Access Compliance Report

Public Rights-of-Way

(Curb Ramps)

Intersection ID: 3676	Main Street: DENALI_LN	Cross Street: RIVA_RIDGE_CT	Location: NW
ADA ID: 3B96360896E4	Ramp Type: Perp	Initial Pass/Fail: Fail	Overall Compliance: No
Severity Score: 25			
Codes/Mitigation Info/Possible Solution		Field Measurements/Component Compliance

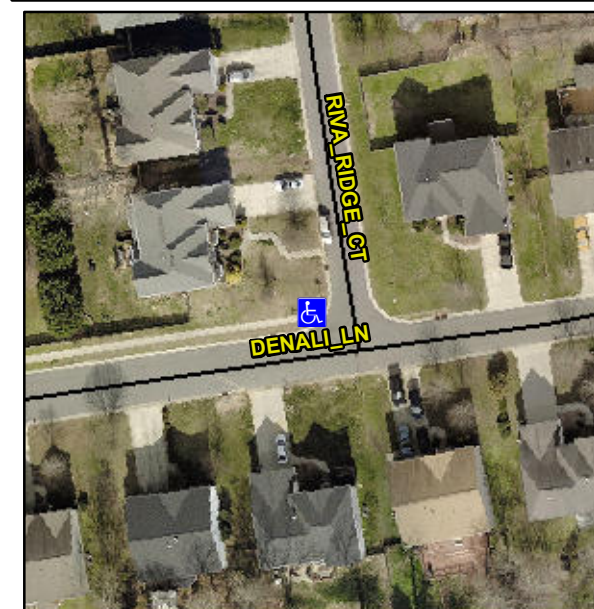
Possible Solutions:

Remove & Replace Entire Ramp.

Not Found, R304.5.3
